AL SUMELAT
WATER NETWORK
VILLAGE OF AL SUMELAT, IRAQ

SIGIR PA-05-004
MARCH 15, 2006

SIGIR PA-2005-004

Al Sumelat Water Network Village of Al Sumelat, Iraq Synopsis

Figure 1: Al Sumelat Pipeline Location Map

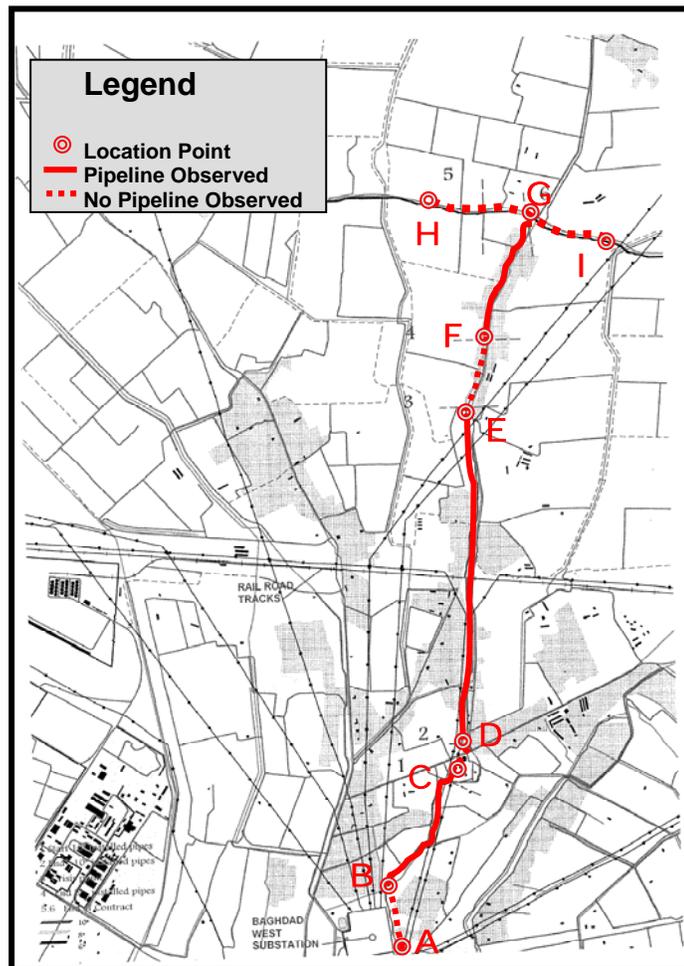
On July 3, 2005, our assessment team, which included a professional engineer and an auditor, performed an on-site assessment of the Al Sumelat Water Network project. The on-site assessment included a visual check of over 92% of the pipeline route. It assessed completed and pending work. No work was observed in progress during the site assessment. Figure 1 shows the general pipeline layout including reference points. The

Point A to B: The approximate length of the pipeline from point A to point B (see the locator map in Figure 1 on page 4) is 840 meters. Disturbed soil leading in the direction of the pipeline route was observed from point A. The disturbed soil appeared to be the result of a recent trench excavation and subsequent backfilling of the trench (Site photo 2). It could not be determined how far this excavation continued. The starting point of the pipeline was not visibly protruding from the disturbed soils and could not be located at point A. An observation at point B leading back toward point A along the proposed pipeline path was of an open field showing no recently disturbed soil (Site photo 3). Consequently, no evidence that the pipeline had been installed between points A and B was found.

Point B: Point B on the locator map in Figure 1 on page 4 is the point at which the pipeline route crosses underneath an irrigation canal. A recently excavated tunnel approximately 1 meter by 1/2 meter was observed underneath the irrigation canal. The pipeline was not visible leading into (Site photo 4) or exiting the

Point B to C: The approximate length of the pipeline from point B to point C (see the locator map in Figure 1 on page 4) is 1,495 meters. Uncapped endpoints of the pipeline were observed at both points B and C (Site photos 5 & 6). The pipe diameter looked to be approximately 225 millimeters, but accurate measurements were not obtained at this location. Disturbed surface soil was observed continuously between points B and C along the proposed pipeline route. The disturbed soil appeared to be the result of a recent trench excavation and subsequent backfilling of the trench. A sand base was not present at the endpoints of the pipeline. A significant amount of unconsolidated soil was observed above grade along the pipeline path. Lack of compacting during backfilling operations would result in the presence of the observed excess soil. The surface of the disturbed soil was uneven with several feet variation in height along the pipeline route. This indicates that final surface grading was not completed. It appeared, based on site assessment observations, that the pipeline had been installed between points B and C, but the pipeline installation was not consistent with contract requirements.

Point C to D: The approximate length of the pipeline from point C to point D (see the locator map in Figure 1 on page 4) is 110 meters. The pipeline route crosses a road intersection at this location. A recently excavated tunnel approximately 1 meter by ½ meter was observed beneath the road intersection.

Point D to E: The pipeline leg from point D to point E (see the locator map in Figure 1 on page 4) is approximately 3,389 meters in length. This section parallels the road and crosses underneath a set of railroad tracks. The endpoint could not be located at point D and an uncapped endpoint of 225 millimeter diameter pipeline was observed at point E. Disturbed surface soil was observed continuously between points D and E along the proposed pipeline route. The disturbed soil appeared to be the result of a recent trench excavation and subsequent backfilling of the trench. A sand base was not present at the endpoints of the pipeline. A significant amount of unconsolidated soil was observed above grade along the pipeline path. Lack of compacting during backfilling operations would result in the presence of the excess soil. The surface of the disturbed soil was uneven with several feet variation in height along the pipeline route. This demonstrates final surface grading was not completed. It appeared, based on site assessment observations, that the pipeline had been installed between points D and E, but the pipeline installation was not consistent with contract requirements.

Point E to F: The pipeline leg from point E to point F (see the locator map in Figure 1 on page 4) is approximately 703 meters in length. This section parallels and crosses under the roadway. A recently dug open trench approximately 1 meter in depth was observed along the proposed pipeline route. Pipe was not visible and the bottom of the trench excavation appeared to be undisturbed soil. At the location where the proposed pipeline route crosses underneath the road a recently excavated tunnel, approximately 1 meter by ½ meter was observed. The pipeline was not visible and could not be located leading into or exiting the tunnel. The bottom of the tunnel excavation appeared to be undisturbed soil. Consequently, no evidence that the pipeline had been installed between points E and F was found. Prior to the site visit, this section of the pipeline was identified as not being completed by the USACE Quality Assurance Representative and is listed in this report under the section on “Work Pending.”

Point F to G: The pipeline leg from point F to point G (see the locator map in Figure 1 on page 4) is approximately 1,315 meters in length. Uncapped endpoints of a 225 millimeter pipeline were seen at both point F and point G. A short section of the pipeline trench, which was only partially backfilled, clearly indicated that sand base was not used (Site photo 7). Disturbed surface soil was observed along the remainder of the proposed pipeline between point F and G. The disturbed soil appeared to be the result of a recent trench excavation and subsequent backfilling of the trench. A significant amount of unconsolidated soil was observed above grade along the pipeline path. Lack of compacting during backfilling operations would result in the presence of the observed excess soil. The surface of the disturbed soil was uneven with several feet variation in height

Point H to I: The pipeline leg from point H to point I (see the locator map in Figure 1 on page 4) is approximately 2,571 meters in length. A recently dug open trench approximately 1 meter in depth was observed along the proposed pipeline route. Pipe was not visible and the bottom of the trench excavation appeared to be undisturbed soil. Consequently, no evidence that the pipeline had been installed between points H and I was found.

No work was in progress at the time of our site assessment on July 3, 2005. The contractor was not on site during the site assessment. The only equipment observed near the site was a backhoe located adjacent to the open trench excavation near point I, in Figure 1 on page 4. Materials required for the completion of the project were not observed anywhere along the proposed pipeline route.
